Gorgon Gas Development Revised and Expanded Proposal: Barrow Island Nature Reserve

**Report and recommendations
of the Environmental Protection Authority**

**Environmental Protection Authority
Perth, Western Australia
Report 1323
April 2009**

Assessment No. 1727

Figure 1a: *Infrastructure and environmental impact zones in Gorgon gas project area. Approved project with previously predicted zones of impact.*

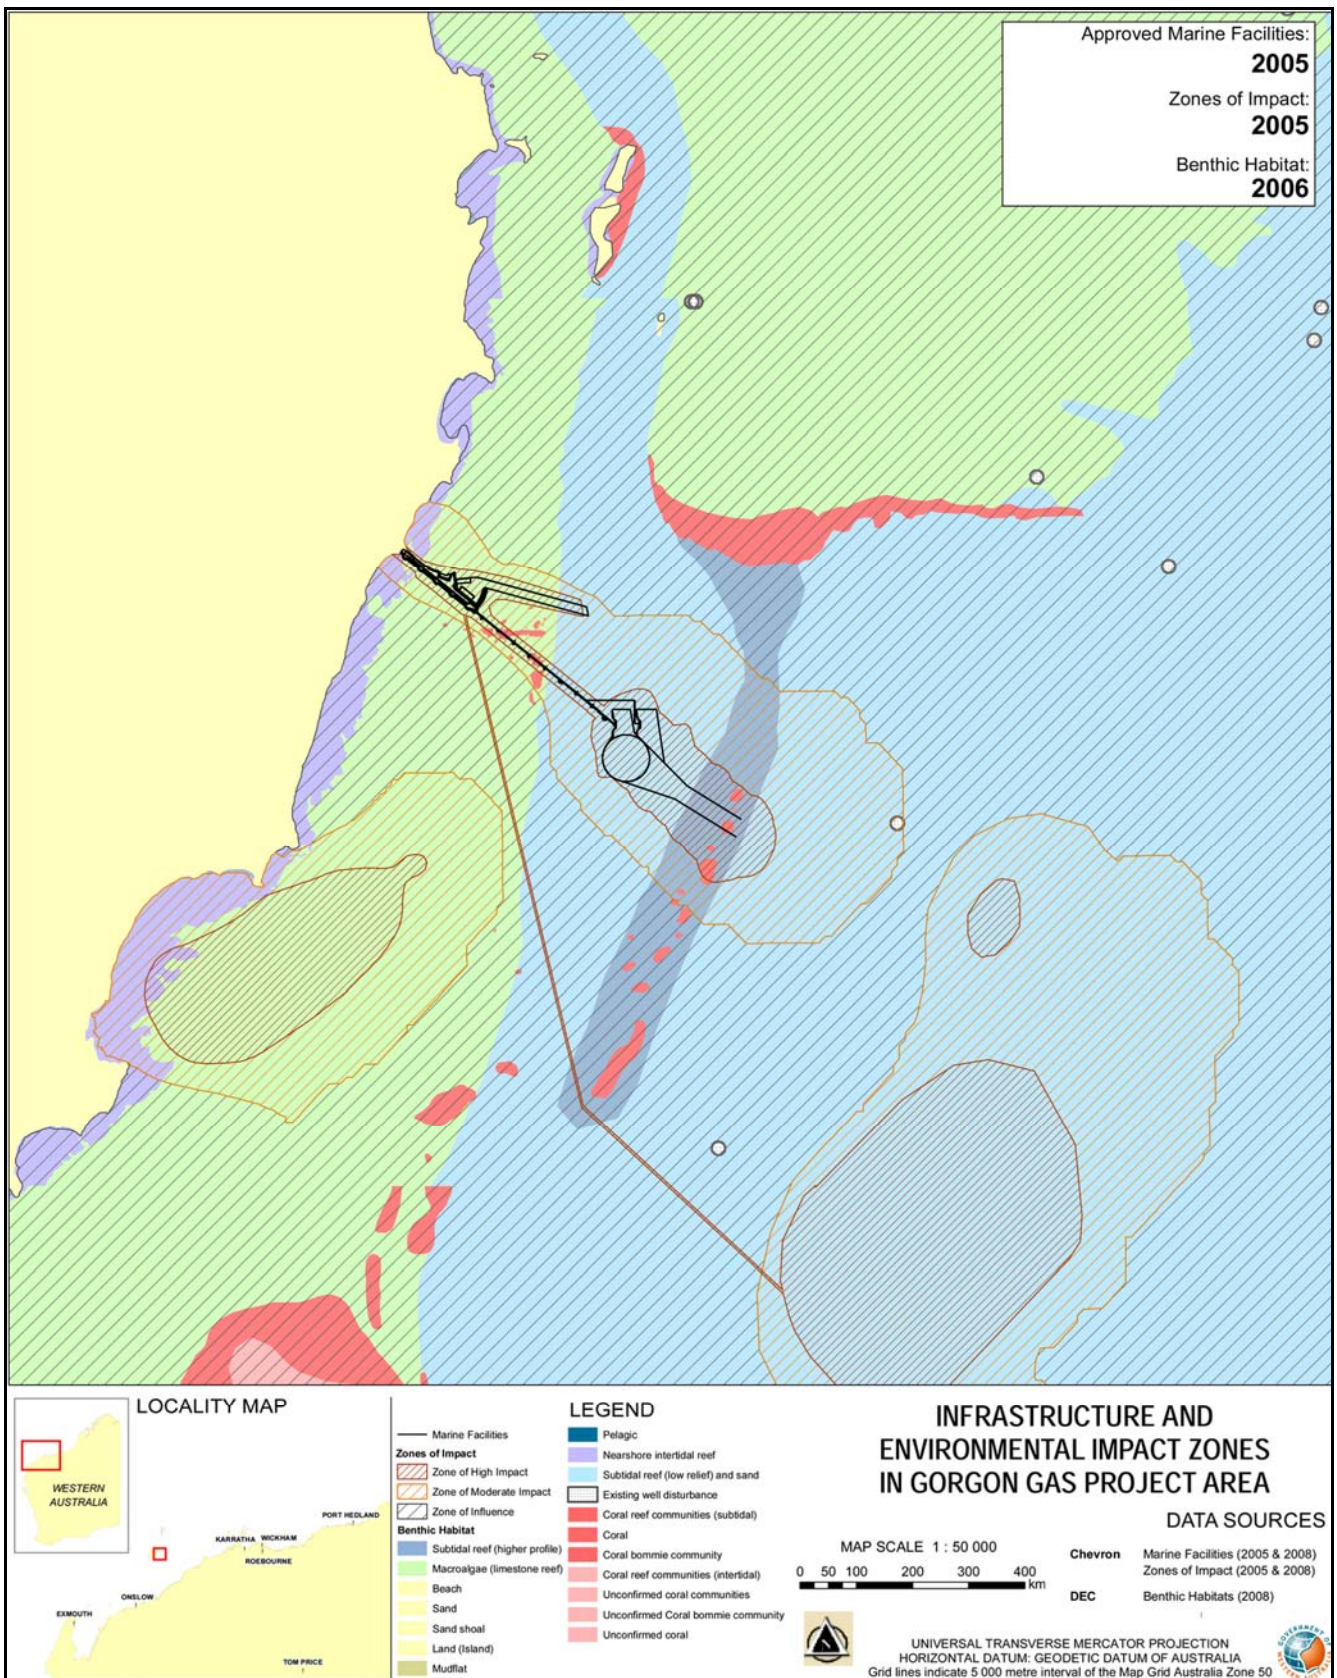
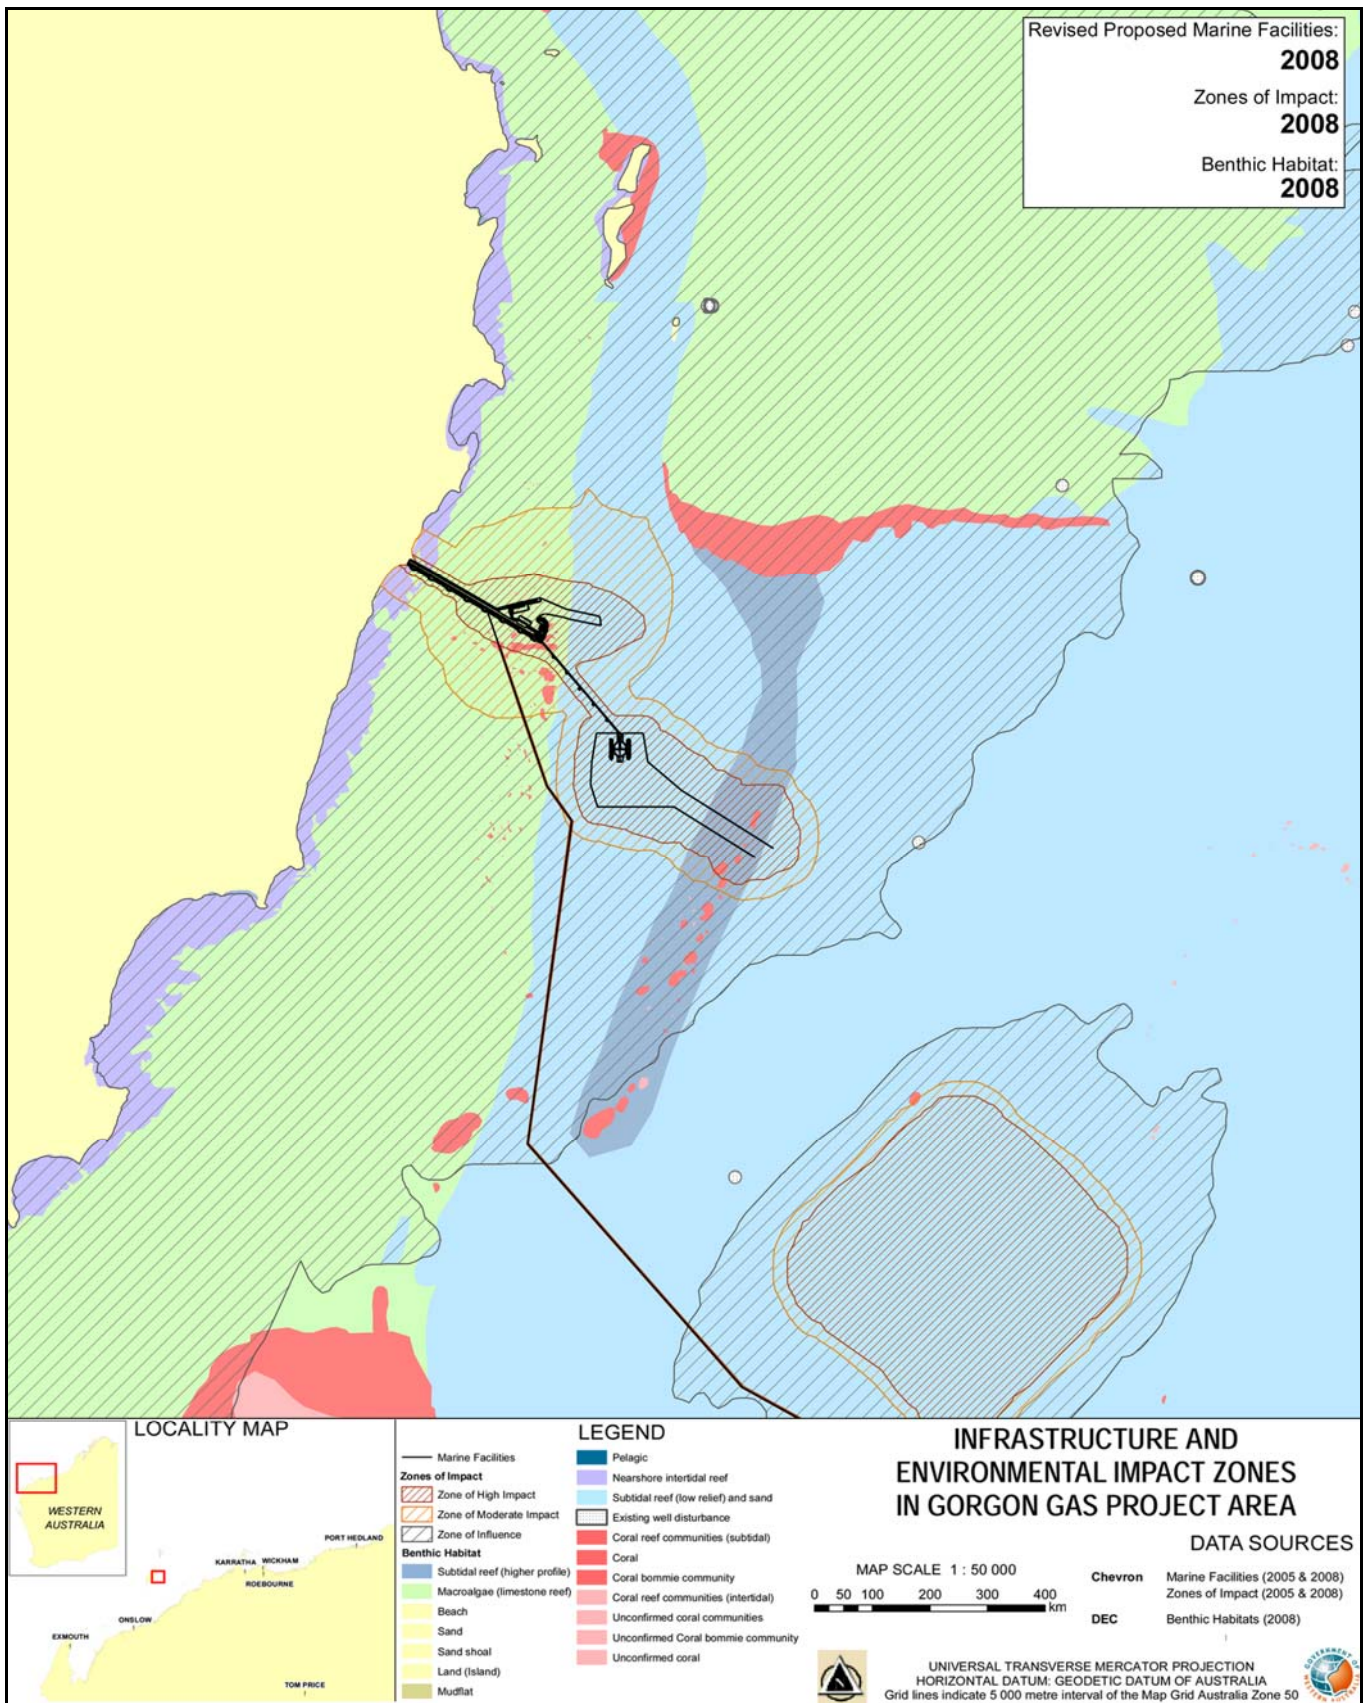
The changes to the proposal have resulted in changes to the predicted extent of turbidity plumes and hence zones of impact around the marine facilities. Table 2 sets out some changes in the area of impact zones in the vicinity of the Lowendal Shelf, as illustrated in Figure 1.

Revised modelling of the expected dredge plumes has removed a predicted area of impact, disconnected from the infrastructure, that was originally predicted to occur to the south of Town Point (Figure 1a and 1b). This will deliver an improved environmental outcome. The extent of predicted impact zones has also contracted in other areas, remote from the Lowendal Shelf. This too is an improvement.
